**Town of Surfside
SPECIAL PLANNING & ZONING BOARD
AGENDA**

February 11, 2021 – 6:00 p.m.

To: Planning and Zoning Board
Thru: Andrew Hyatt, Town Manager
From: Walter Keller, PE, AICP., Town Consultant Planner
Marlin Engineering, Inc.
CC: Jason Greene, Assistant Town Manager
Lillian Arango, Town Attorney
Date February 1, 2021
RE: 9133 – 9149 Collins Avenue – Seaway Condo Acquisition LLC – Site Plan Amendment

PROPOSED WEST ELEVATION (FRONT)

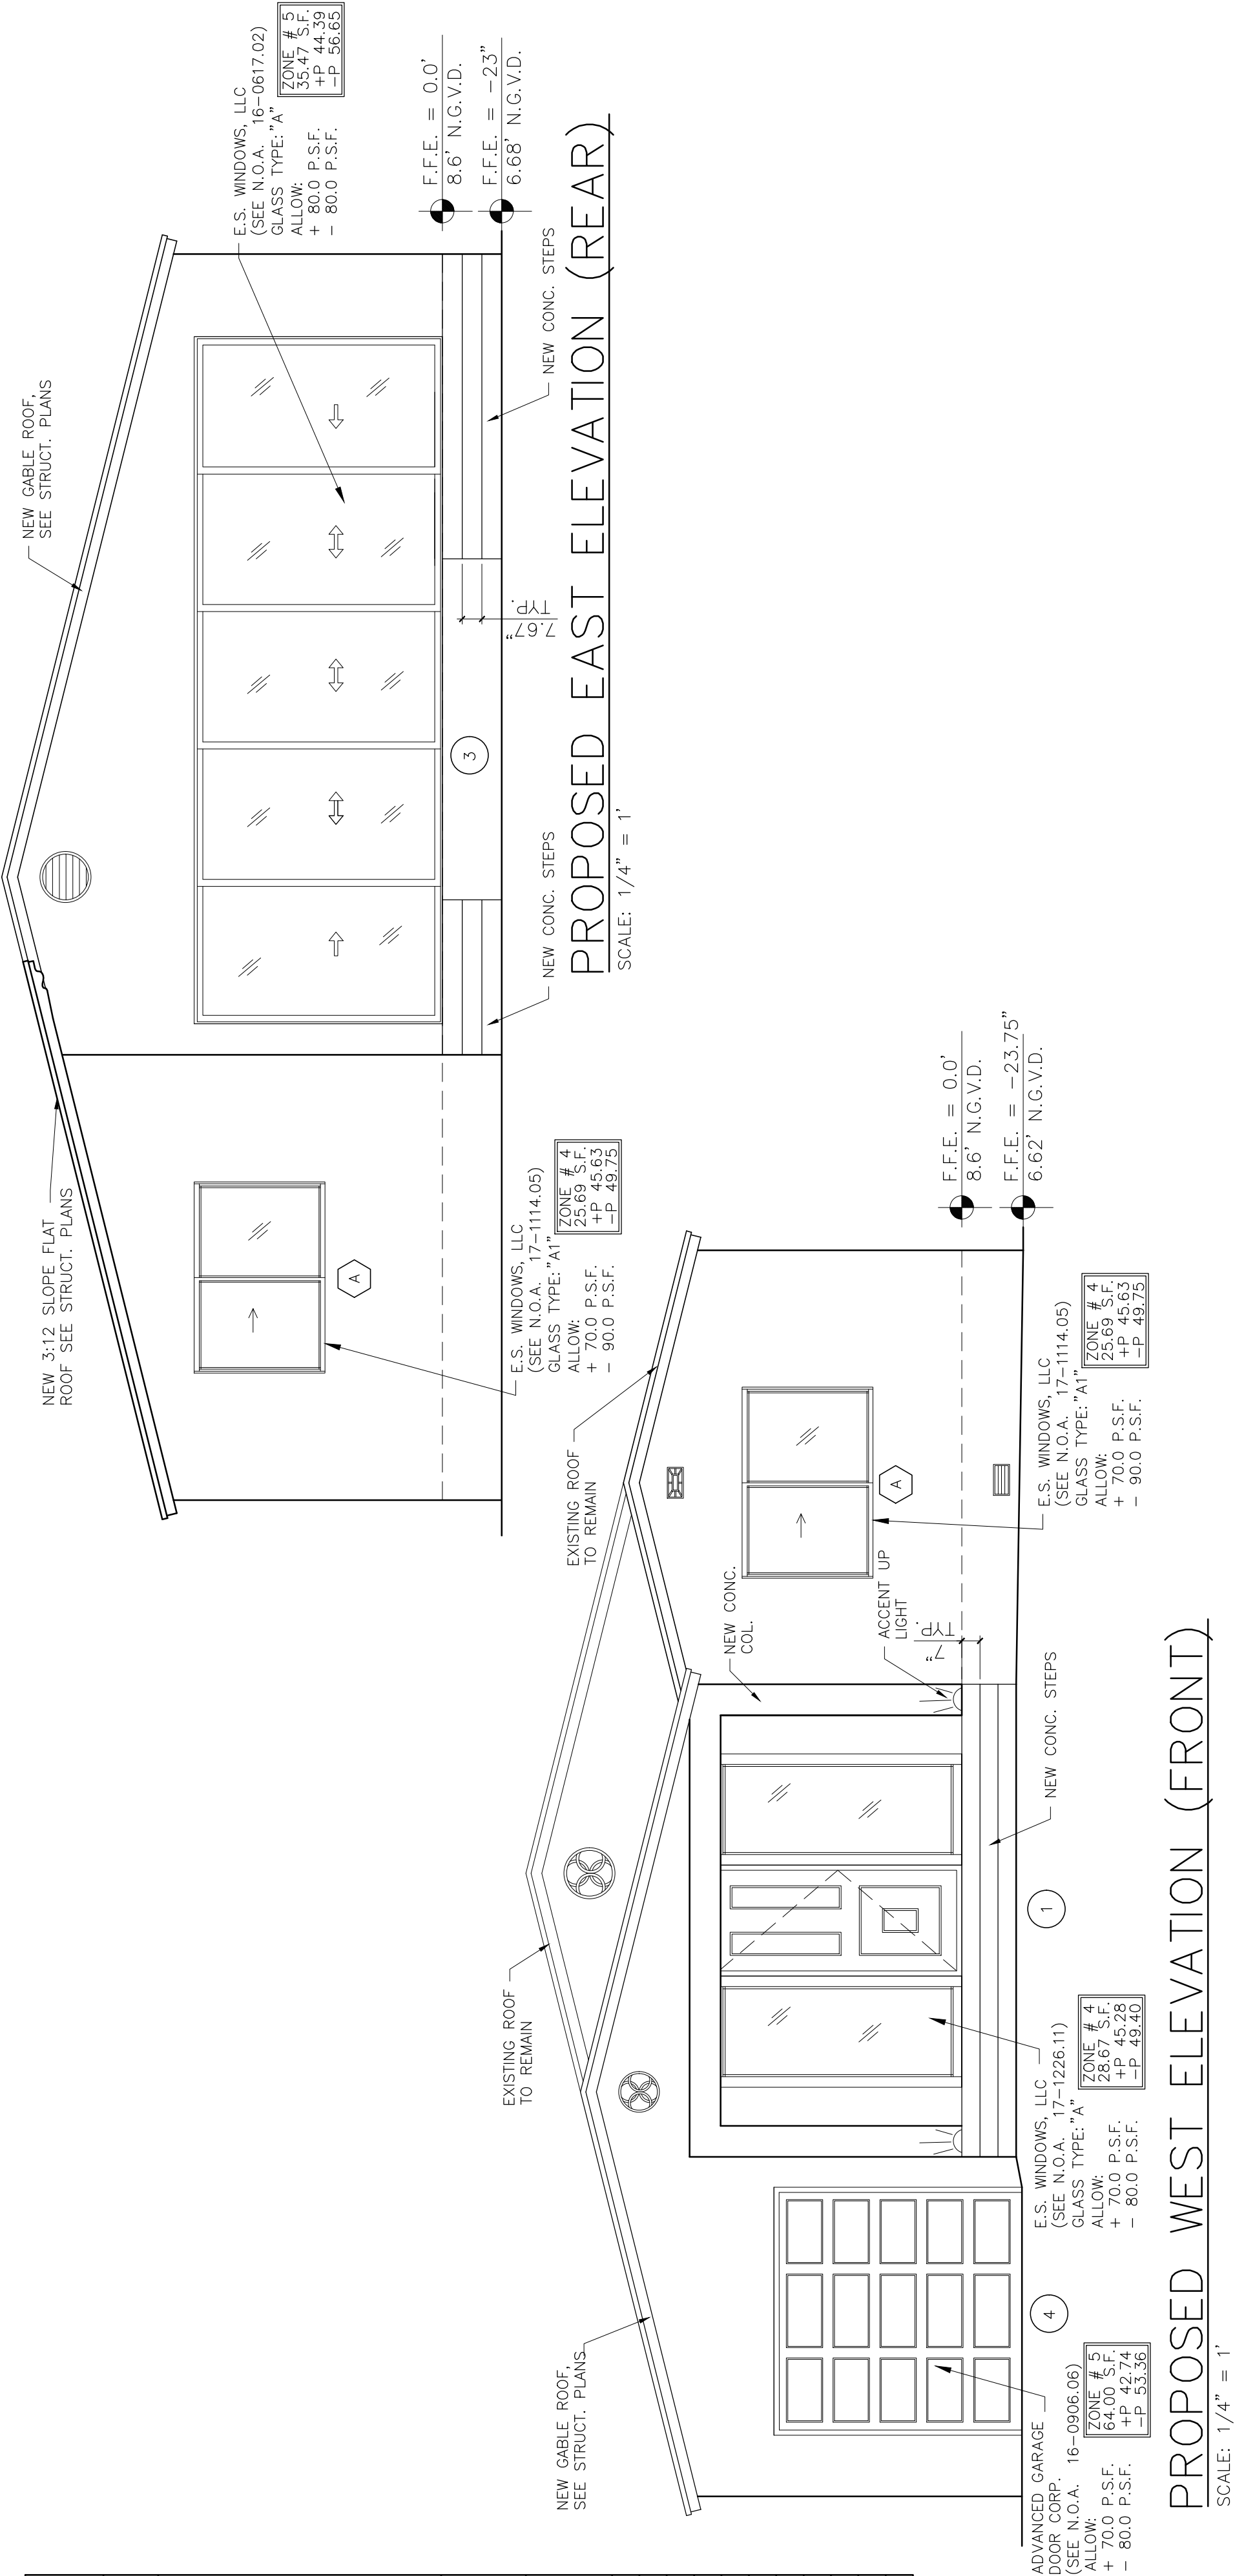
The Applicant submitted additional information to address pervious area, compliance with front and rear yard landscape area and modifications of the front yard hardscape. Additional revisions were made to revise the front elevation in the vicinity of the front door – porch area.
